HISTORIC AND DESIGN REVIEW COMMISSION

December 05, 2018

HDRC CASE NO: 2018-580
ADDRESS: 206 CAMARGO
LEGAL DESCRIPTION: NCB 924 BLK 5 LOT N 134 FT OF 2
ZONING: RM-4, H
CITY COUNCIL DIST.: 1
DISTRICT: Lavaca Historic District
APPLICANT: Michael Taritas
OWNER: Michael Taritas
TYPE OF WORK: Exterior modifications, rehabilitation, fenestration modifications, construction of a rear addition, fencing and driveway installation
APPLICATION RECEIVED: November 15, 2018
60-DAY REVIEW: January 16, 2019
REQUEST:

1912 SANBORN MAP

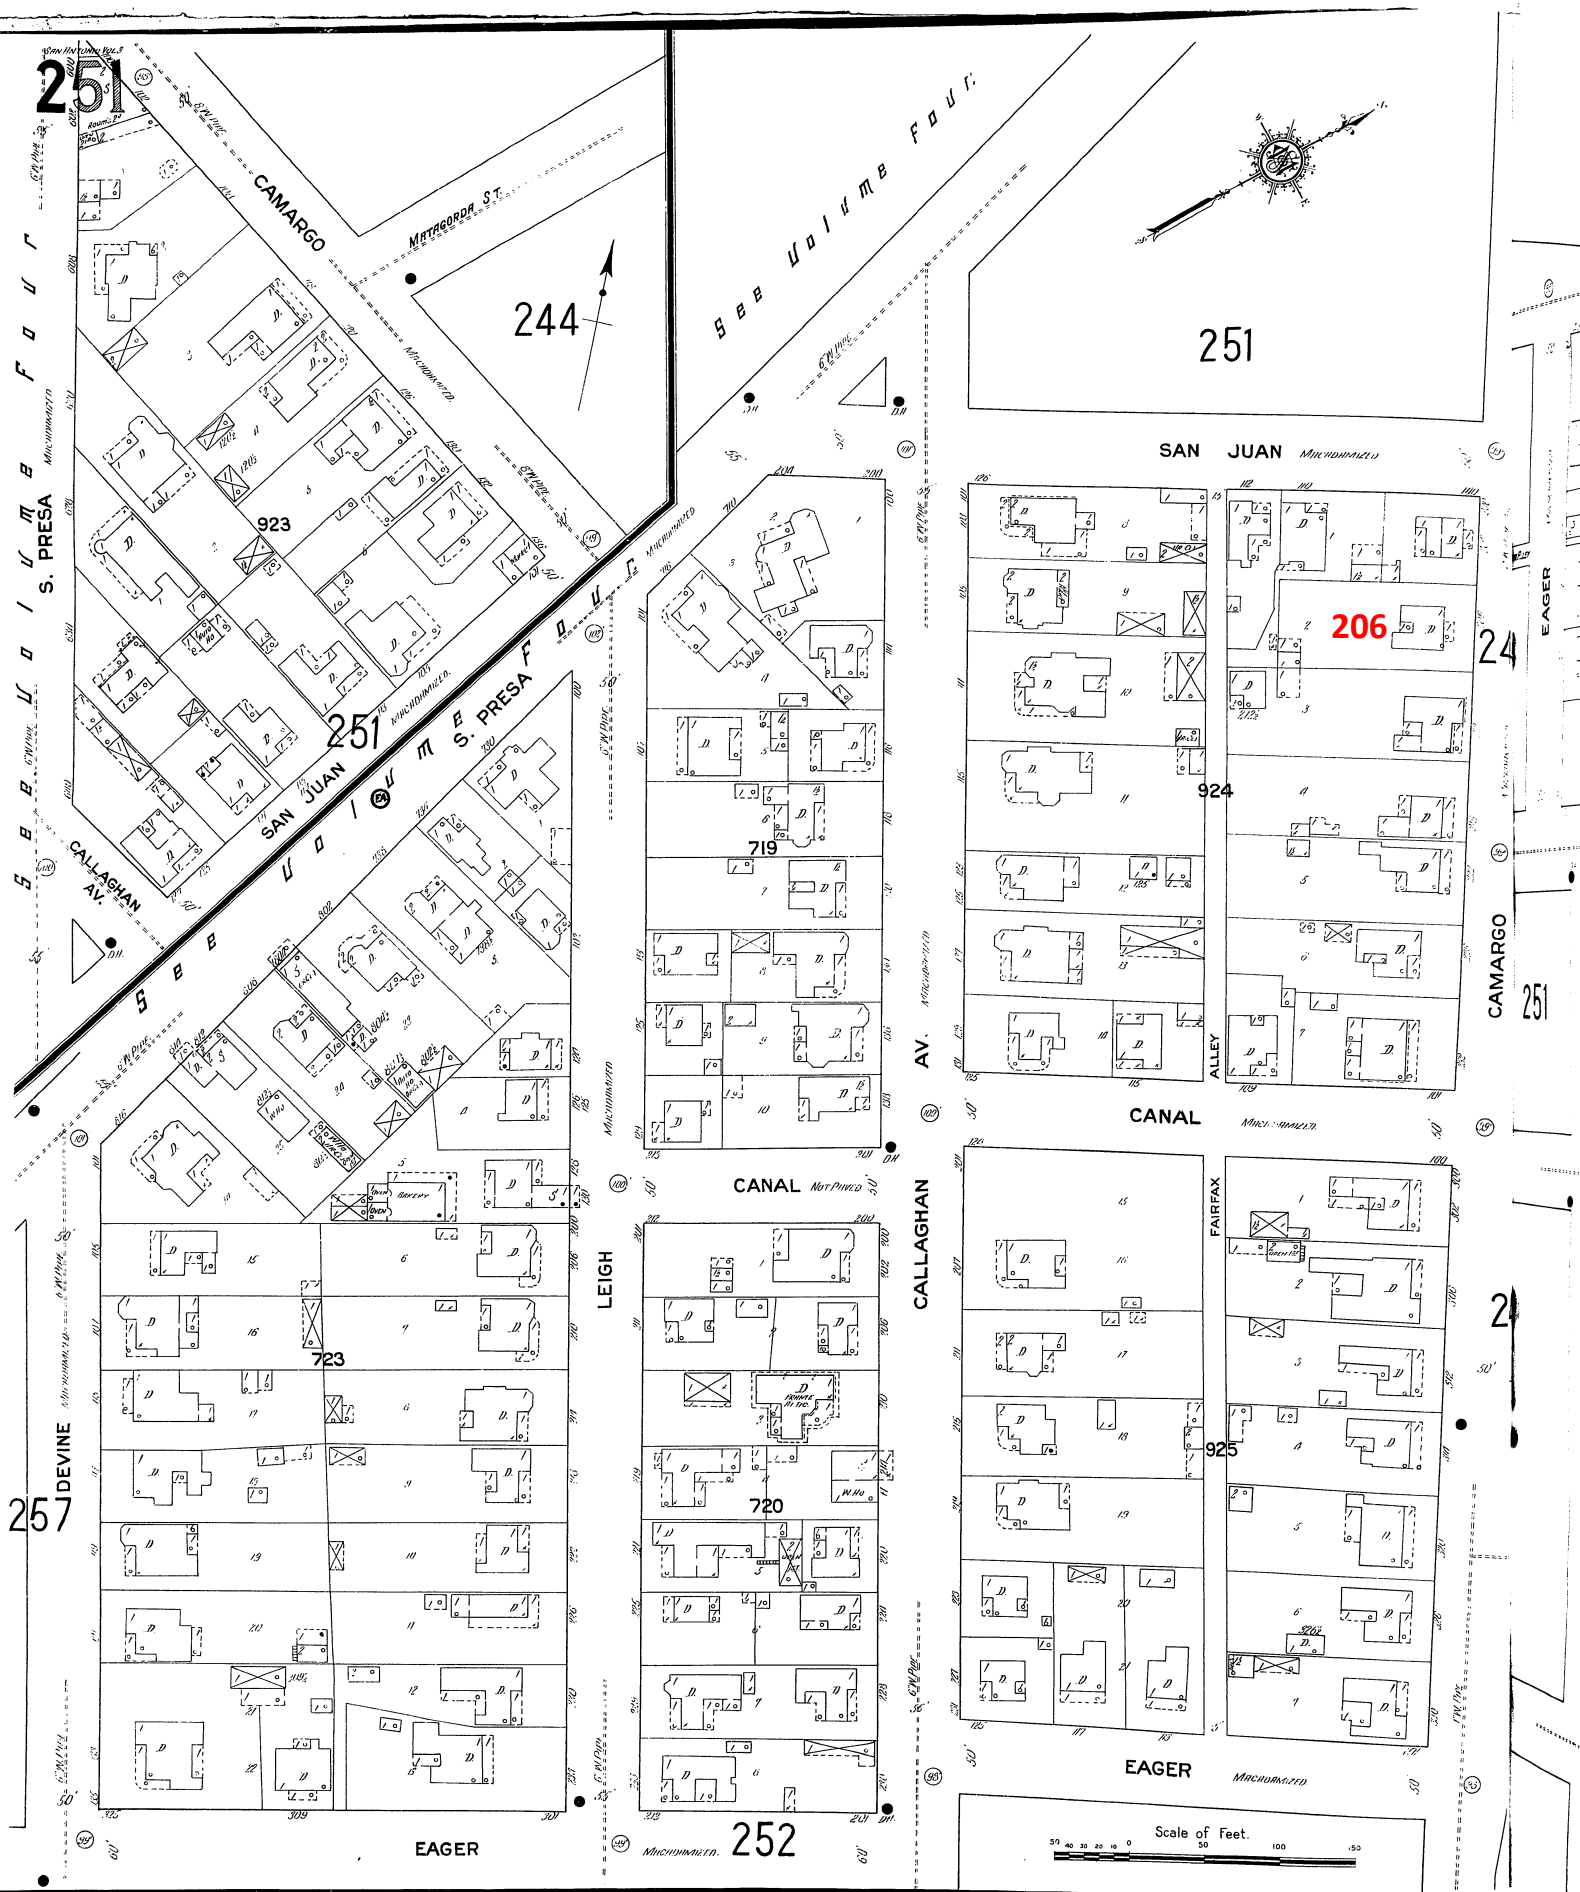
- a. The historic structure at 206 Camargo was constructed circa 1900 and is first found on the 1904 Sanborn Map. The structure features side gabled roofs with a rear gable as well as contributing additions that are found on both the 1912 and 1951 Sanborn Maps. The structure is contributing to the Lavaca Historic District.

- c. REMOVAL OF ADDITIONS – The applicant has proposed to remove a series of contributing rear additions, including a contributing addition to the rear of the original structure, found on the 1904 Sanborn Map; a contributing addition to the previously noted addition which is found on the 1912 Sanborn Map; and a contributing screened porch addition to the rear of the primary structure rear facing gable which is found on the 1951 Sanborn Map. Staff finds that each of these additions holds historic integrity and does not recommend approval.

1. Staff does not recommend approval of item #1, the demolition of the existing, contributing rear additions based on finding c. Staff recommends that the demolished contributing additions be reconstructed as they previously existed.

PHOTOS OF DEMOLISHED ADDITIONS

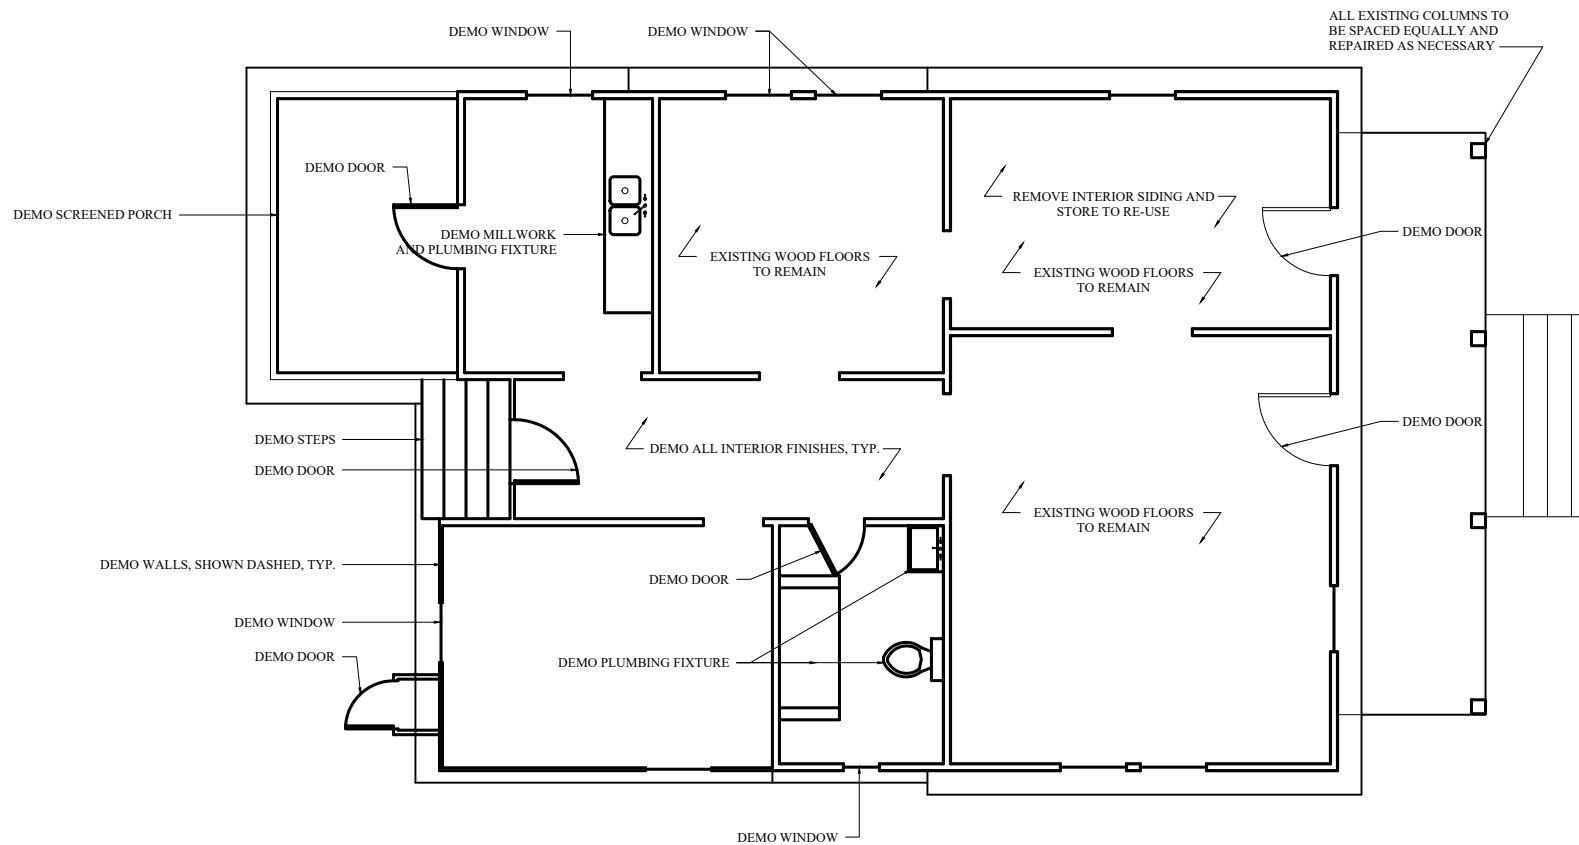
- b. SITE VISIT – OHP conducted a site visit on November 28, 2018, where a stop work order was issued. OHP staff observed the unapproved removal of the existing, contributing rear additions and foundation and floor framing work in preparation for the construction of a rear addition.
